工程指示 / 要求簡箋(E.I.)

工程指示編號：EI / 5272 / 22

工程名稱：將軍澳日出康城 LP 11

工程項目：幕牆 大貨單元件加工圖

**AS-05A**

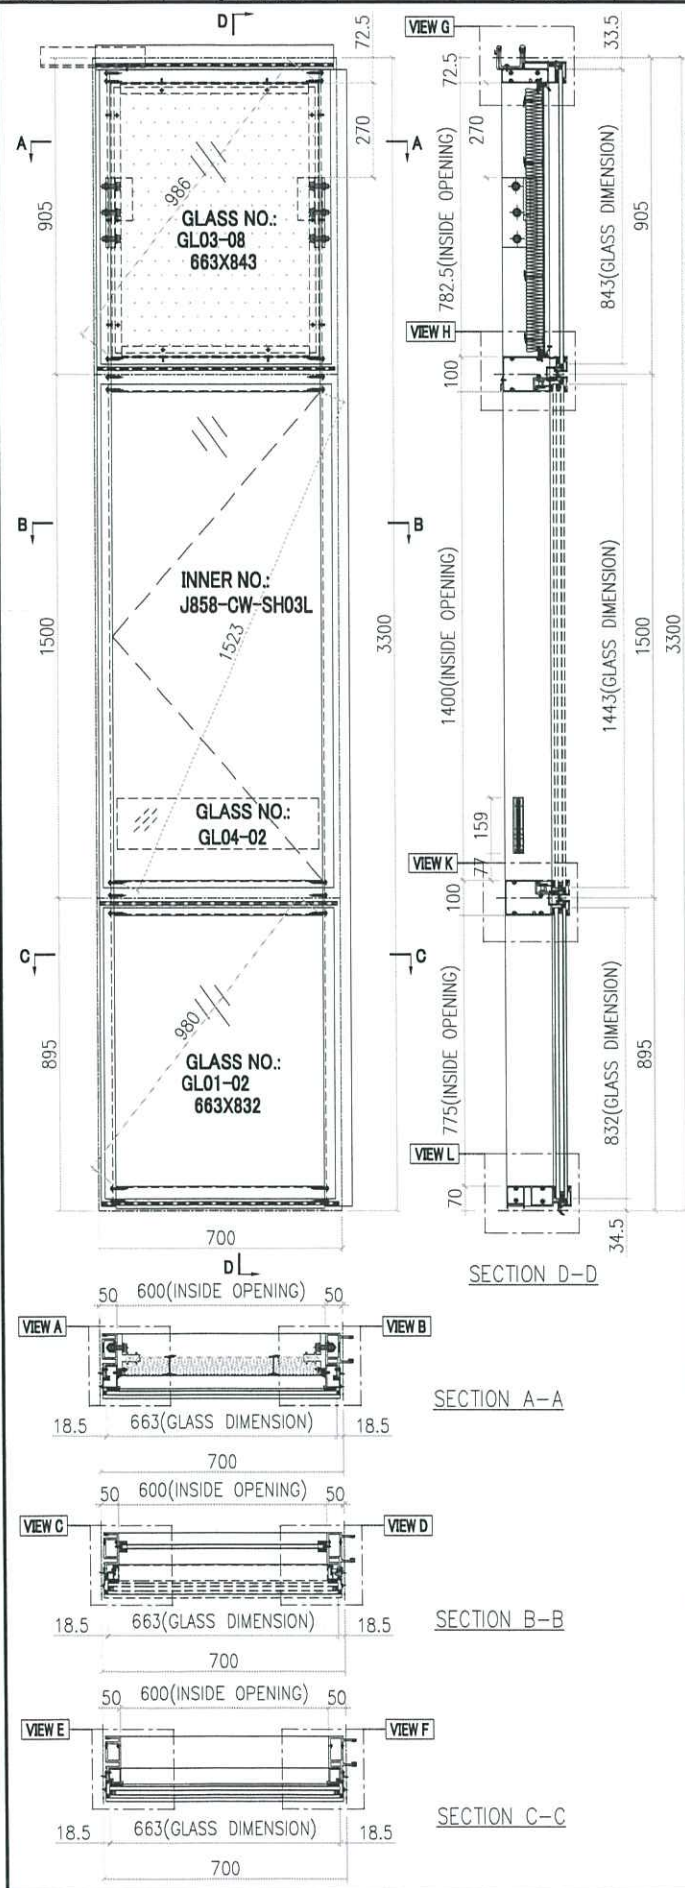
K版: 修改 AS 05A 一張,

**Lohas P11 - Rectification of Curtain Wall Window Division between 2 Flats**

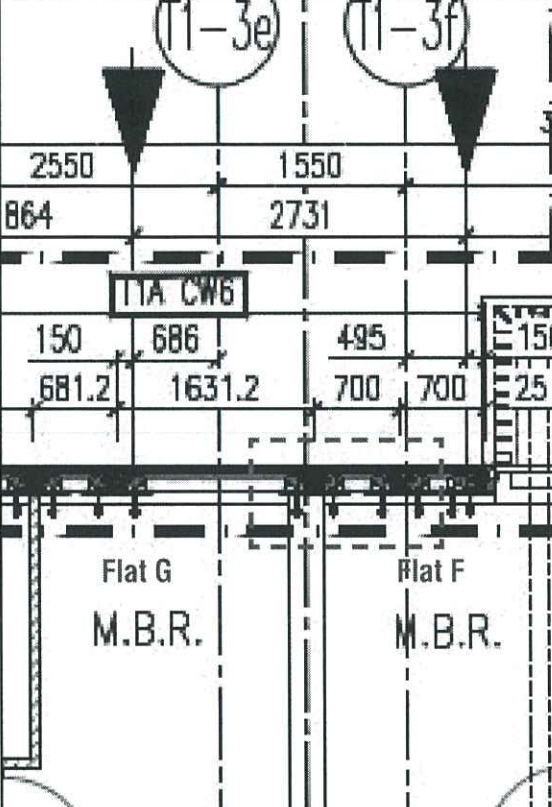
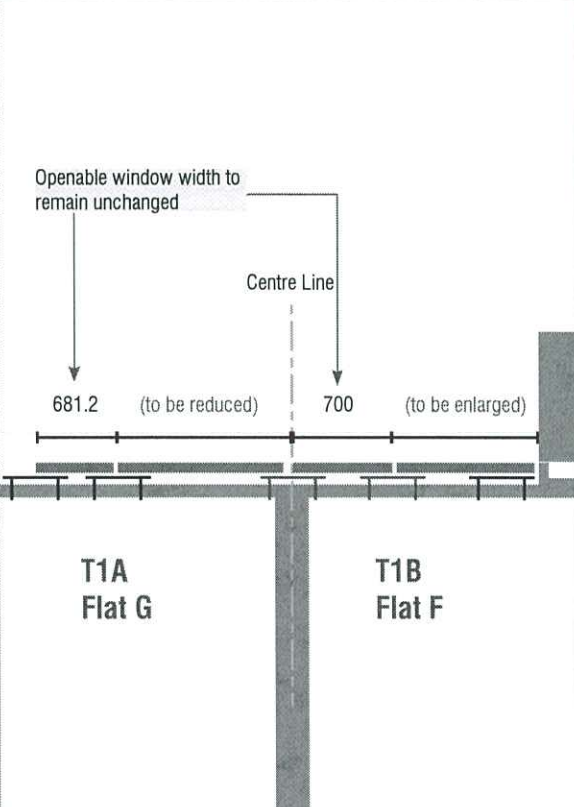
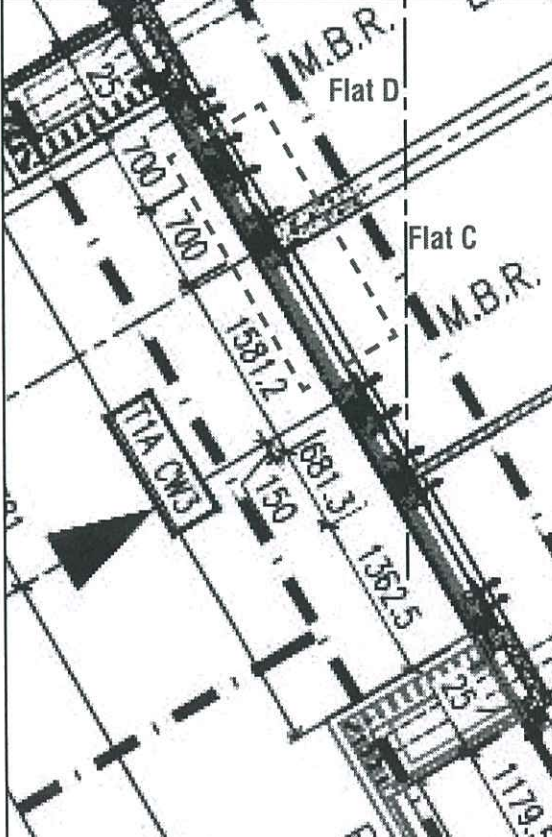
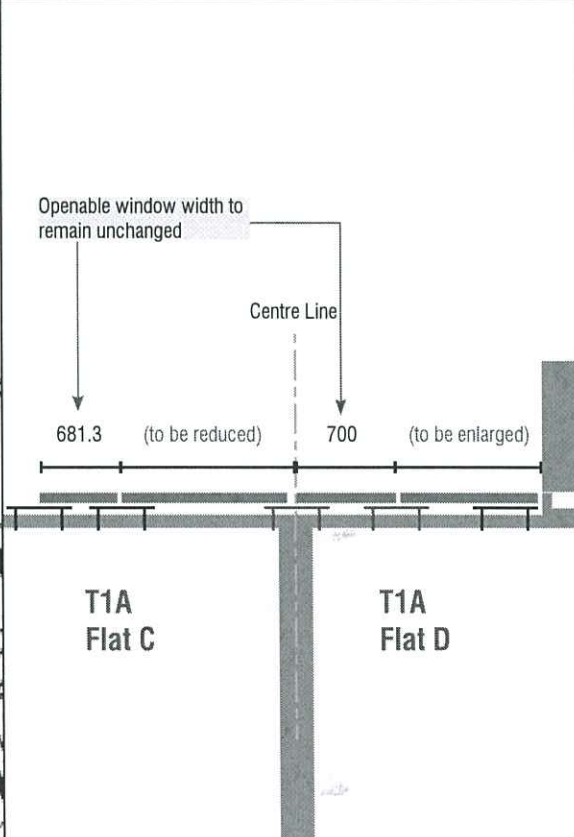
| Location                   | Shop Drawing  | Rectification  |
|----------------------------|---|--|
| T1A Flat G &<br>T1B Flat F |  <p>Shop drawing showing window dimensions for T1A Flat G and T1B Flat F. Key dimensions include 2550, 1550, 864, 2731, 150, 686, 495, 150, 681.2, 1631.2, 700, 700, 25. Labels include T1-3e, T1-3f, T1A CW6, Flat G M.B.R., and Flat F M.B.R.</p> |  <p>Rectification diagram for T1A Flat G and T1B Flat F. It shows the openable window width to remain unchanged, the center line, and the required adjustments: 681.2 (to be reduced) and 700 (to be enlarged).</p> |
| T1A Flat C &<br>Flat D     |  <p>Shop drawing showing window dimensions for T1A Flat C and Flat D. Key dimensions include 2550, 700, 700, 1581.2, 150, 681.3, 150, 1382.5, 25, 1179.5. Labels include T1A CW5, Flat C M.B.R., and Flat D M.B.R.</p>                             |  <p>Rectification diagram for T1A Flat C and Flat D. It shows the openable window width to remain unchanged, the center line, and the required adjustments: 681.3 (to be reduced) and 700 (to be enlarged).</p>    |

**Lohas P11 - Rectification of Curtain Wall Window Division between 2 Flats**

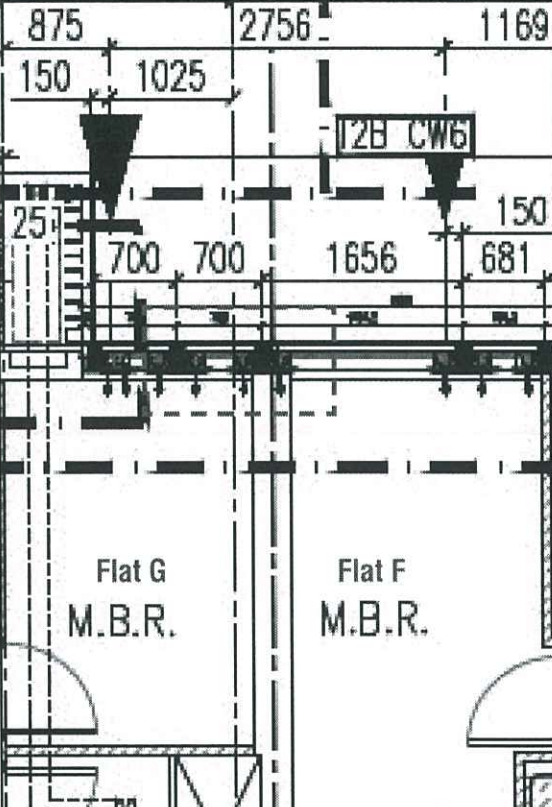
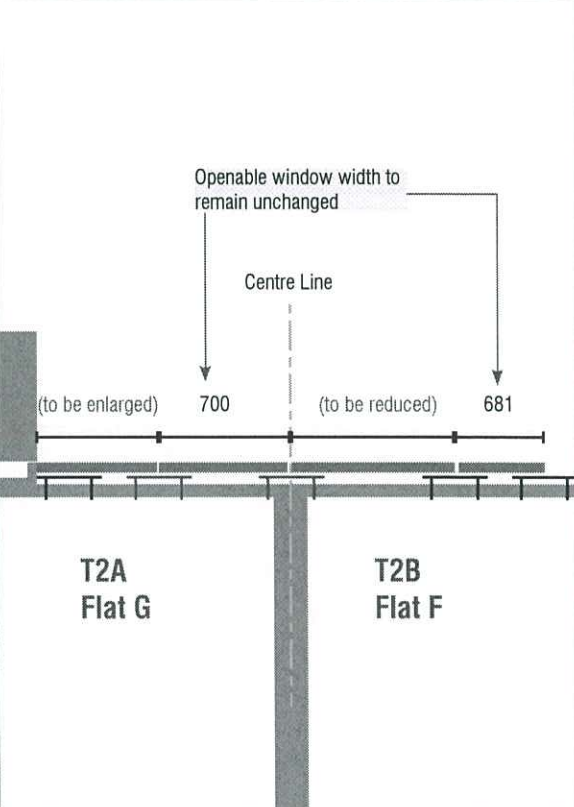
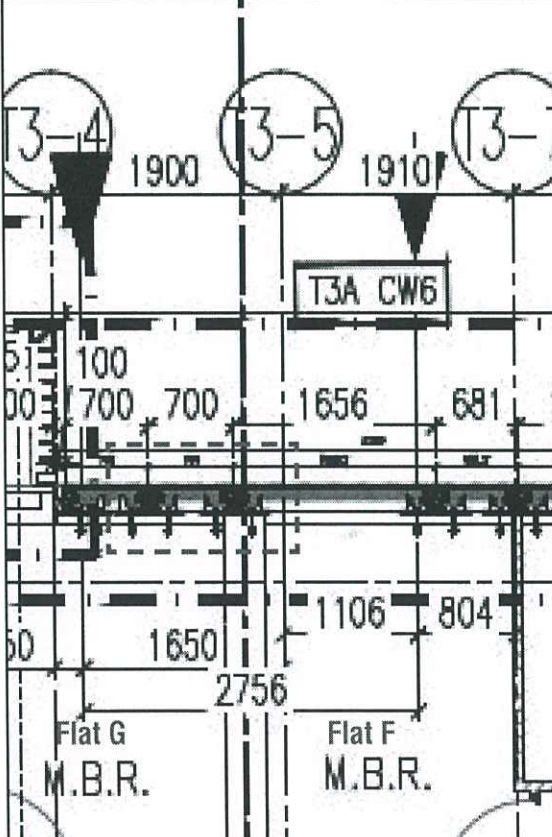
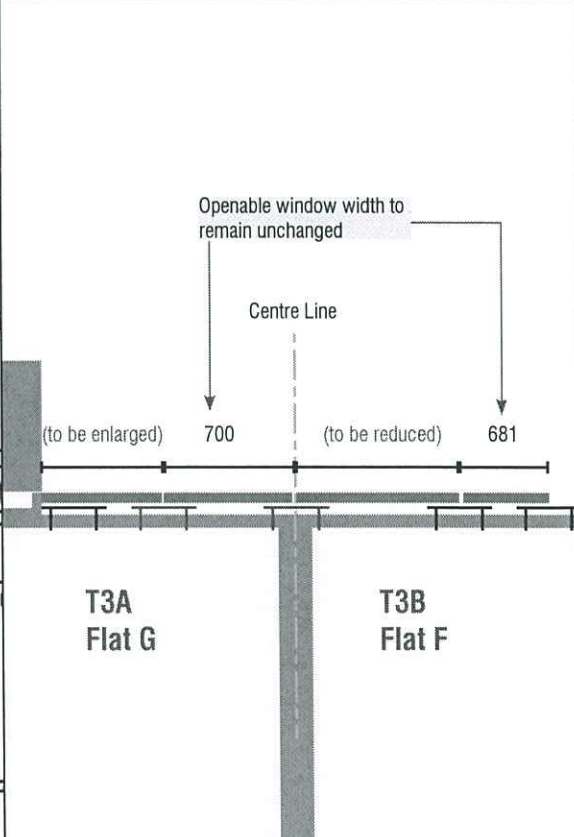
| Location                | Shop Drawing  | Rectification  |
|-------------------------|---|--|
| T2A Flat G & T2B Flat F |  <p>Shop drawing details for T2A Flat G and T2B Flat F. Dimensions include: 875, 2756, 1169, 150, 1025, 12B CW6, 25, 700, 700, 1656, 681, 150. Labels include Flat G M.B.R. and Flat F M.B.R.</p>                         |  <p>Rectification diagram for T2A Flat G and T2B Flat F. It shows a horizontal line representing the window division with a vertical dashed 'Centre Line'. The left side is labeled '(to be enlarged)' with a dimension of 700. The right side is labeled '(to be reduced)' with a dimension of 681. A bracket above the line indicates 'Openable window width to remain unchanged'.</p>  |
| T3A Flat G & T3B Flat F |  <p>Shop drawing details for T3A Flat G and T3B Flat F. Dimensions include: 1900, 1910, 13-4, 13-5, 13-7, 51, 100, 700, 700, 1656, 681, 1, 50, 1650, 2756, 1106, 804. Labels include Flat G M.B.R. and Flat F M.B.R.</p> |  <p>Rectification diagram for T3A Flat G and T3B Flat F. It shows a horizontal line representing the window division with a vertical dashed 'Centre Line'. The left side is labeled '(to be enlarged)' with a dimension of 700. The right side is labeled '(to be reduced)' with a dimension of 681. A bracket above the line indicates 'Openable window width to remain unchanged'.</p> |
